Access Audit Site Report

Lake Arrowhead State Park

Accessibility Evaluation

Inspection Date: 05/18/2022

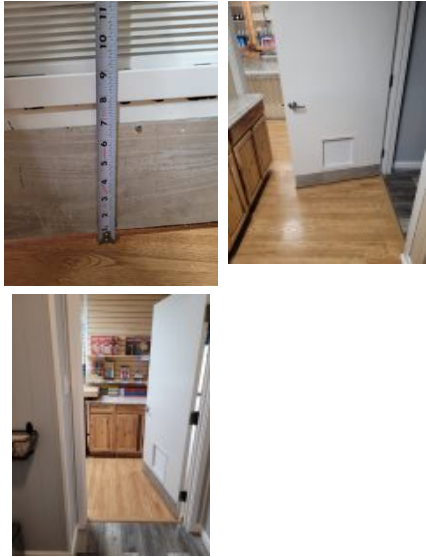
Finding Number	Area Description	Lat/Long	Finding	As Built	Recommendation	Citation	Photos	Figure
11	Headquarters Area: HQ - Public Spaces	[33.7584952, -98.3951088], [33.7586268, -98.3951423]	There is no accessible route to the garbage cans and firewood dispenser. At least one accessible route shall connect accessible buildings, accessible facilities, accessible elements, and accessible spaces that are on the same site.	Lacks route to 2 garbage, firewood	Create an accessible route with crushed stone or other outdoor material from parking or walkway to the firewood dispenser. Relocate 20% of garbage cans to be along AR.	2015 ABAAS Section: F206.2.2 2012 TAS Section: 206.2.2 2010 ADAS Section: 206.2.2		
12	Headquarters Area: HQ - Public Spaces	[33.7586223, -98.3951321]	The operable part is positioned too high for either a side or front approach. Where a clear floor or ground space allows a parallel approach to an element and the side reach is unobstructed, the high side reach shall be 48 inches maximum and the low side reach shall be 15 inches minimum above the finish floor or ground. Where a forward reach is unobstructed, the high forward reach shall be 48 inches maximum and the low forward reach shall be 15 inches minimum above the finish floor or ground.	Payment controls at firewood dispenser at 55" AGL	Remount operable parts to be in reach range of 15" min to 48" max.	2015 ABAAS Section: 308.1 2012 TAS Section: 308.1 2010 ADAS Section: 308.1

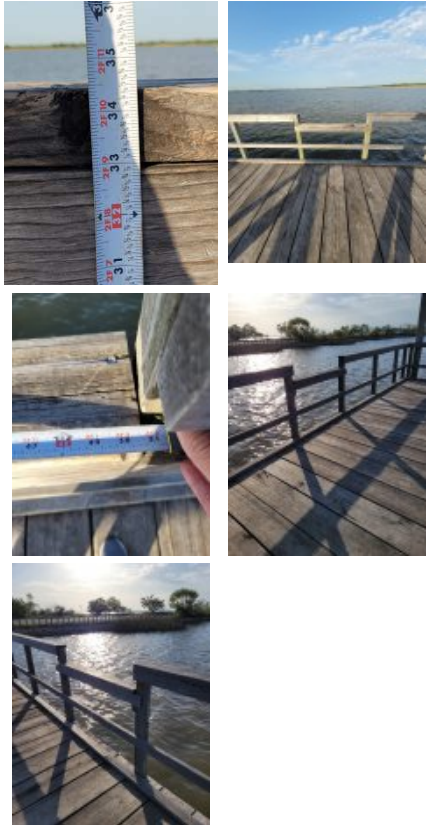
Finding Number	Area Description	Lat/Long	Finding	As Built	Recommendation	Citation	Photos	Figure
23	Headquarters Area: HQ - Public Restroom	[33.75861, -98.39523]	The restroom is not compliant. The restroom does not have the required minimum clear floor space or maneuvering clearances for the toilet. The restroom does not have the required minimum clear floor space or maneuvering clearances for the lavatory. The entry door does not contain the required minimum maneuvering spaces on the pull/push sides. The entry door encroach into the required clear floor space for fixtures. Grab bars are missing and/or incorrectly installed. Accessories, such as toilet seat covers, paper towel holders, garbage cans, hand dryers, and mirrors are either too high or without clear floor space or both.	Public restroom does not have accessible features; 67" x 84"	Create a compliant wheelchair accessible restroom and correct all features to be accessible if feasible.	2015 ABAAS Section: 603.1 2012 TAS Section: 603.1 2010 ADAS Section: 603.1

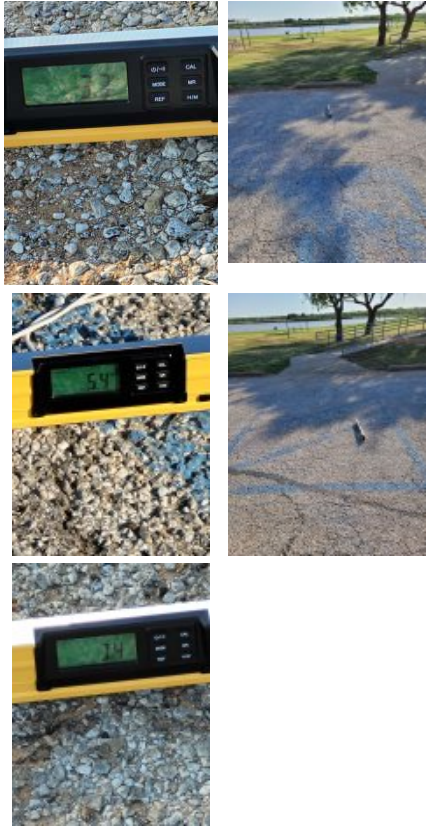
Finding Number	Area Description	Lat/Long	Finding	As Built	Recommendation	Citation	Photos	Figure
41	Public Spaces: Playground	[33.7558615 , -98.3852066]	Play area shall have signage listing designated ages of intended users.	play area by boat ramp- lacks posted ages of intended users	Acquire and install intended user signage and mount at designated entry as a smart practice.	2015 ABAAS Section: F240.1 2012 TAS Section: 240.1 2010 ADAS Section: 240.1		
42	Public Spaces: Playground	[33.7535501 , -98.3862366]	Compliance with ASTM F 1951 for accessibility for ground surfaces on accessible routes, clear floor or ground spaces, and turning spaces has not been determined. Ground surfaces shall comply with ASTM F 1951. Ground surfaces shall be inspected and maintained regularly and frequently to ensure continued compliance with ASTM F 1951.	play area by boat ramp- Sand surface	Frequently inspect and regularly Replace existing surface with an accessible surface such as EWF, PIP or tiles, with compliant slopes and CILs.	2012 TAS Section: 1008.2.6.1 2010 ADAS Section: 1008.2.6.1

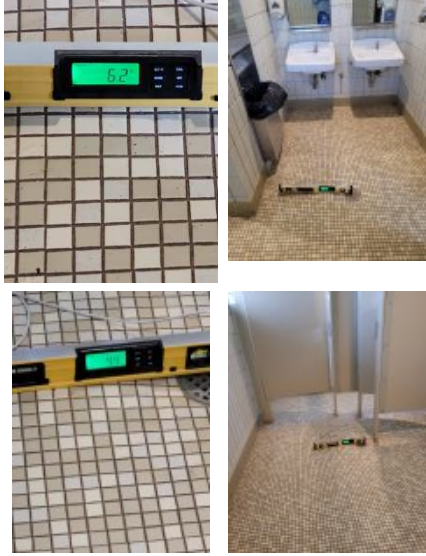
Finding Number	Area Description	Lat/Long	Finding	As Built	Recommendation	Citation	Photos	Figure
98	Public Spaces: Boat Ramp Day Use Men's Restrooms	[33.7541745 , -98.388157]	The restroom sign does not comply with one or more applicable requirements for the location, height, and properties of the sign.	Day Use Men's Restroom - Lacks compliant signage and location	Replace sign with one of contrasting colors that includes Braille, raised characters, and the symbol of accessibility and mount on the wall, latch side of the door, 48" to the baseline of the lowest character and 60" to the baseline of the highest character.	2015 ABAAS Section: F216.2, 703.1, 703.2, 703.5, 703.6 2012 TAS Section: 216.2, 703.1, 703.2, 703.5, 703.6 2010 ADAS Section: 216.2, 703.1, 703.2, 703.5, 703.6		
99	Public Spaces: Boat Ramp Day Use Men's Restrooms	[33.7541812 , -98.3881651]	The mirror is mounted too high. Mirrors must have the bottom edge of the reflecting surface a maximum of 40 inches above the floor if above a sink or counter. Mirrors not located above lavatories or countertops shall be installed with the bottom edge of the reflecting surface 35 inches maximum above the finish floor or ground.	Day Use Men's Restroom - Bottom edge at 41" AFF, top edge at 70.25" AFF	Replace mirror so bottom reflective surface is max 40" AFF and 74" at the top.	2015 ABAAS Section: 603.3 2012 TAS Section: 603.3 2010 ADAS Section: 603.3

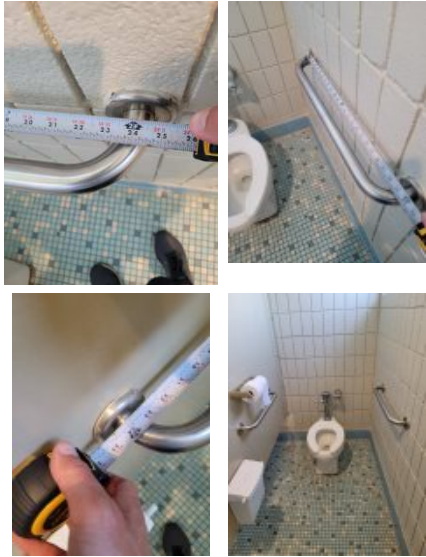
Finding Number	Area Description	Lat/Long	Finding	As Built	Recommendation	Citation	Photos	Figure
113	Public Spaces: Boat Ramp Day Use Women's Restrooms	[33.7542054 , -98.3882056]	The accessible route of travel contains cross slopes greater than 2%. Cross slopes shall not exceed one unit vertical in 48 units horizontal (2-percent slope).	Day Use Restrooms - Slope of 3.2% to women's restroom, 3.7% to men's	Correct or repair cross slope along AR to max 2.08%.	2015 ABAAS Section: 403.3 2012 TAS Section: 403.3 2010 ADAS Section: 403.3		
114	Public Spaces: Boat Ramp Day Use Women's Restrooms	[33.75419, -98.3881683]	Minimum maneuvering clearances at doors and gates shall comply with 404.2.4. Maneuvering clearances shall extend the full width of the doorway and the required latch side or hinge side clearance. Maneuvering clearances shall have a max slope of 2.08%.	Day Use Women's Restroom Door - 8.8% slope in clearance of restroom door	For all doors along the public circulation route, correct slope in door clearance to max 2.08%.	2010 ADAS Section: 404.2.3, 404.2.7, 404.2.4, 404.2.11, 404.2.11 Exception

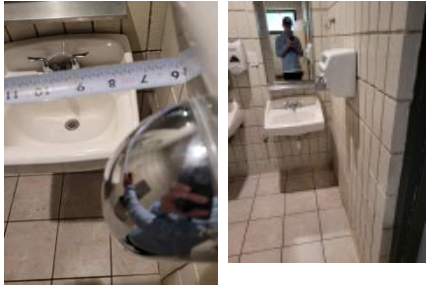
Finding Number	Area Description	Lat/Long	Finding	As Built	Recommendation	Citation	Photos	Figure
169	Camping Area: Men's Restroom	[33.7589044 , -98.386785 1]	The mirror is mounted too high. Mirrors must have the bottom edge of the reflecting surface a maximum of 40 inches above the floor if above a sink or counter. Mirrors not located above lavatories or countertops shall be installed with the bottom edge of the reflecting surface 35 inches maximum above the finish floor or ground.	Bottom edge at 41" AFF, and top edge at 70" AFF	Replace mirror so bottom reflective surface is max 40" AFF and 74" at the top.	2015 ABAAS Section: 603.3 2012 TAS Section: 603.3 2010 ADAS Section: 603.3		
170	Camping Area: Men's Restroom	[33.7589099 , -98.386791 8]	Knee clearance at 27 inches off the floor is not 8 inches minimum deep. The knee clearance, measured from the bottom of the apron or the outside bottom edge of the lavatory, must be 27 inches at a point located 8 inches back from the front edge and continuing to 11 inches minimum in depth at 9 inches above the floor. The top of the lavatory rim may be no higher than 34 inches. The operable part is not accessible because there is not adequate clear floor space for either a forward or side approach. The clear floor or ground space shall be 30 inches minimum by 48 inches minimum.	Sink knee clearance 25" AFF, and lacks CFS due to garbage and hand dryer	Replace sink with one providing 27" knee clearance that is a min 8" deep. Remove, or relocate garbage and hand dryer in CFS at fixtures and operable parts along the AR.	2015 ABAAS Section: 306.3.1, 306.3.2, 306.3.3, 306.3.4 , 306.3.5 2012 TAS Section: 306.3.2, 306.3.3, 306.3.4, 306.3.5, 306.3.1 2010 ADAS Section: 306.3.3, 306.3.2, 306.3.4, 306.3.5, 306.3.1

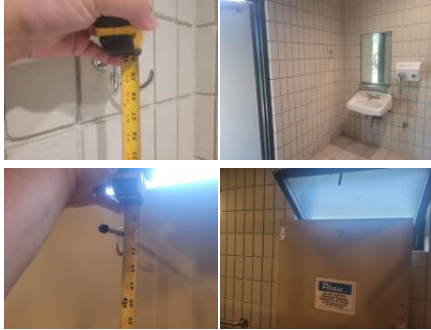
Finding Number	Area Description	Lat/Long	Finding	As Built	Recommendation	Citation	Photos	Figure
177	Camping Area: Men's Restroom	[33.75892, -98.386790 4]	The side grab bars are not in the correct location. Grab bars on the side wall must be installed so that the end closest to the rear wall is maximum 12" from the rear wall. The end furthest from the rear wall must be mounted minimum 54" from the rear wall.	Right bar starts 13" from rear wall, and left bar starts 13.5" from rear wall	Remount side grab bar to max 12" from the rear wall at the close end and min 54" on the far end, and 33" to 36" AFF.	2015 ABAAS Section: 604.5.1 2012 TAS Section: 604.5.1 2010 ADAS Section: 604.5.1		
178	Camping Area: Men's Restroom	[33.7589155 , -98.386789 1]	The toilet paper is not installed within the compliant range in front of the toilet. Toilet paper dispensers shall be 7 inches minimum and 9 inches maximum in front of the water closet measured to the centerline of the dispenser. The outlet of the dispenser shall be 15 inches minimum and 48 inches maximum above the finish floor and shall not be located behind grab bars. Dispensers shall not be of a type that controls delivery or that does not allow continuous paper flow. There shall be a clearance of 1 1/2 inches minimum below the grab bar.	TP too close to front of toilet	Remount toilet paper dispenser max 7" to 9" from front of toilet, 15" to 48" AFF and min 12" above or 1.5" below grab bar.	2015 ABAAS Section: 604.7 2012 TAS Section: 604.7 2010 ADAS Section: 604.7

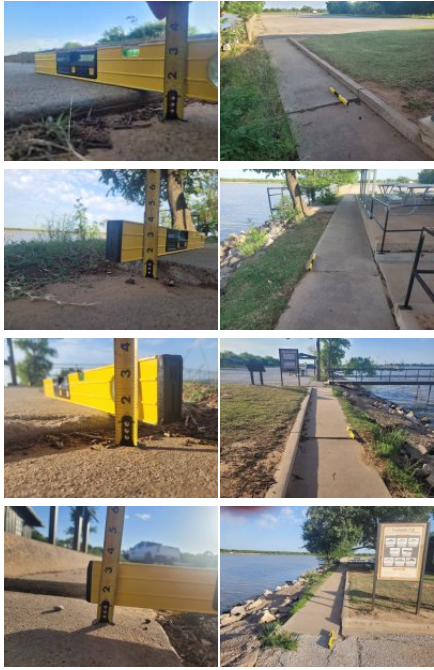
Finding Number	Area Description	Lat/Long	Finding	As Built	Recommendation	Citation	Photos	Figure
234	Employee Areas: Maintenance	[33.7614877 , -98.3868119]	Spaces and elements within employee work areas shall only be required to comply with 206.2.8, 207.1, and 215.3 and shall be designed and constructed so that individuals with disabilities can approach, enter, and exit the employee work area. Employee work areas, or portions of employee work areas, other than raised courtroom stations, that are less than 300 square feet (28 m2) and elevated 7 inches (180 mm) or more above the finish floor or ground where the elevation is essential to the function of the space shall not be required to comply with these requirements or to be on an accessible route.	gravel at several entries, CILs, knobs	For employee spaces, relocate storage, furniture, and other obstacles at doorways to provide approach, enter and exit at the employee space. Provide required maneuvering clearance on push and pull side of doors. Repair, bevel, or ramp CILs at door entries to max .25". Replace hardware with lever hardware or hardware operable without a tight pinch or grasp.	2015 ABAAS Section: F203.9 2012 TAS Section: 203.9 2010 ADAS Section: 203.9

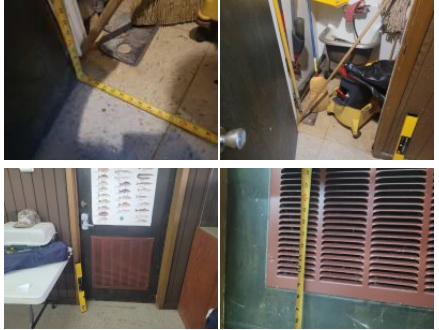
Finding Number	Area Description	Lat/Long	Finding	As Built	Recommendation	Citation	Photos	Figure
249	Employee Areas: Administration	[33.7550799 , -98.3844113]	There is a change in level greater than 1/4 inch. 1/4 inch is the maximum vertical rise. Changes in level between 1/4 inch and 1/2 inch must be beveled at 1:2 or less. Changes in level greater than 1/2 inch must be by way of a ramp.	CIL of .75" at top of ramp	Repair, bevel or ramp CIL along accessible route (AR) to max .25".	2015 ABAAS Section: 303.3 2012 TAS Section: 303.3 2010 ADAS Section: 303.3		
250	Employee Areas: Administration	[33.7550598 , -98.3844354]	The handrail is not continuous the entire length of the ramp. The handrail must be continuous. Handrails shall be placed on each side of each ramp, shall be continuous the full length of the ramp. The inside handrail on switch back or dogleg ramps shall always be continuous. Handrail shall have top and bottom extensions.	Extensions do not continue in direction of travel, may create hazard	Leave as is, lack of extensions as addition of extensions would create a hazard	2015 ABAAS Section: 505.3, 505.10.1 2012 TAS Section: 505.3, 505.10.1 2010 ADAS Section: 505.3, 505.10.1

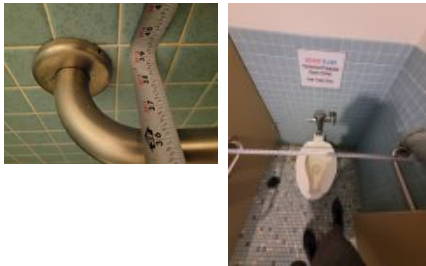
Finding Number	Area Description	Lat/Long	Finding	As Built	Recommendation	Citation	Photos	Figure
264	Employee Areas: Administration Building Men's Restroom	[33.75861, -98.39523]	The restroom sign does not comply with one or more applicable requirements for the location, height, and properties of the sign.	Lacks compliant signage	Replace sign with one of contrasting colors that includes Braille, raised characters, and the symbol of accessibility and mount on the wall, latch side of the door, 48" to the baseline of the lowest character and 60" to the baseline of the highest character.	2015 ABAAS Section: F216.2, 703.1, 703.2, 703.5, 703.6 2012 TAS Section: 216.2, 703.1, 703.2, 703.5, 703.6 2010 ADAS Section: 216.2, 703.1, 703.2, 703.5, 703.6		
265	Employee Areas: Administration Building Men's Restroom	[33.75861, -98.39523]	The mirror is mounted too high. Mirrors must have the bottom edge of the reflecting surface a maximum of 40 inches above the floor if above a sink or counter. Mirrors not located above lavatories or countertops shall be installed with the bottom edge of the reflecting surface 35 inches maximum above the finish floor or ground.	Bottom edge at 41.25" AFF, top edge at 70.5" AFF	Replace mirror so bottom reflective surface is max 40" AFF and 74" at the top.	2015 ABAAS Section: 603.3 2012 TAS Section: 603.3 2010 ADAS Section: 603.3
